Proposed Scope of Notification				
Address:	16-22 Funda Cres, Lalor Park	Proponent:	LAHC	
Property Description:	Lots 360, 361, 362, 363 in DP 31954	Job No:	BGYMP	
LGA:	Blacktown City Council	Planner:	Rajlaxmi Kshirsagar	
			•

Subject: Notice of proposed seniors housing – Attention: Ben Rankmore, Assistant Team Leader (Gateway)

Subject: FW: Statutory Council Notification (Attention: Ben Rankmore) - NSW Land and

Housing Corporation - 16-22 Funda Crescent, Lalor Park (BGYMP)

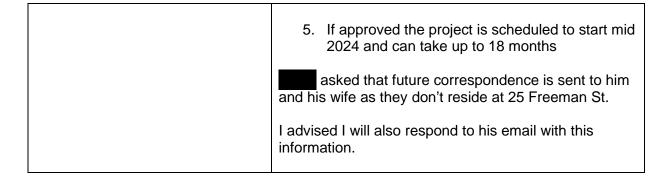
Apologies for not getting revision from our waste section's instruction. Please see below for updated comments from waste. Basically the yellow highlighted is the revised part.

- all waste comments reflect the agreement made between NSW Land and Housing Corporation and BCC Waste Section.
- allow for the LAHC generation rates of 1x240L waste bin and 1x240L recycling bin per 2 units
 - This development requires 9 waste bins and 9 recycling bins.
